**CITY OF OLYMPIA**  
**Olympia Design Review Board**

**CONCEPT DESIGN REVIEW**  
**STAFF REPORT**  
**February 28, 2018**

**Project / Case Number:** Olympia Pediatric Dentistry / 18-5180

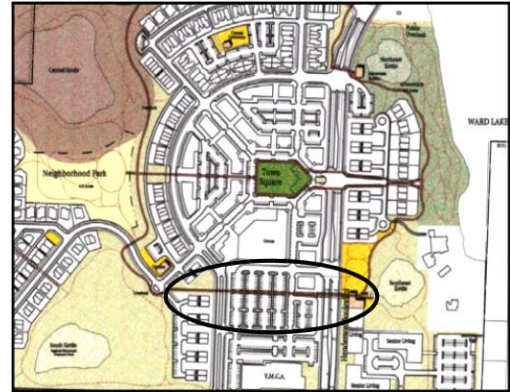
**Building Form and Material:** The proposal achieves the overall design intent outlined in the Briggs Village Design Guidelines. The code emphasizes a desire for a neo-traditional design. Staff looks to the Board to evaluate this project's design to determine if it includes an adequate amount of traditional elements to meld the proposed contemporary elements into the design intent for the village. The project includes several modern elements such as a single pitch roof element, modern siding, decorative angular windows etc. The applicant contends that these elements bring a fun and inviting northwest flavor to the building. Nevertheless, they are not seen in other buildings within the Briggs Village. As this is the first commercial building, it will be

important to consider the proposal in terms of the example it sets for future development.

The main building shows good building massing, provides a mix of commercial and office space in individual tenant spaces and provides higher quality building materials as is required in the design criteria. Both buildings provide a cohesive design and carry design elements to all sides of the buildings.
